APPLICATION NO.	FILING DATE	FIRST NAMED INVENTOR	ATTORNEY DOCKET NO.	CONFIRMATION NO.
09/597,780	06/20/2000	Alessandro Cesare Callegari	YOR-9-2000-0010	6159

Office Action Summary	Application No. 09/597,780	Applicant(s) CALLEGARI ET AL.	
	Examiner HOAN C. NGUYEN	Art Unit 2871

DETAILED ACTION

As Fig. 11 a shown:

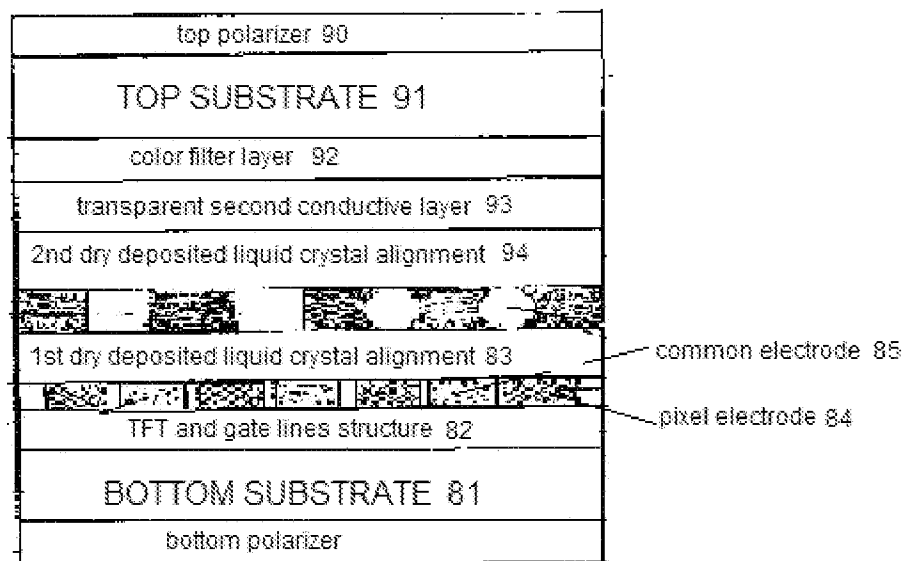
The claims 9 and 37 amends with new feature “a first transparent conductive layer disposed directly on said first surface of said bottom substrate”, which is disclosed in the original specification.

Therefore, **the first transparent conductive layer**, that is pixel electrode 85 or common electrode 84, **is NOT** disposed directly on (contacted to) said first surface of said bottom substrate 81. Therefore, the amended feature in claims 9 and 37 considers as NEW SUBJECT MATTER.

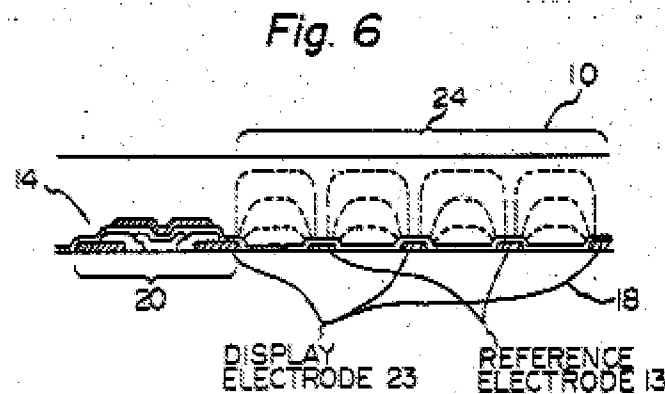
In regard to claims 9 and 37, Oh et al. teach (Fig. 3A-B) a multi-domain liquid crystal display comprising

However, Oh et al. fail to disclose

(amended) a transparent conductive layer disposed directly on said first surface of said bottom substrate
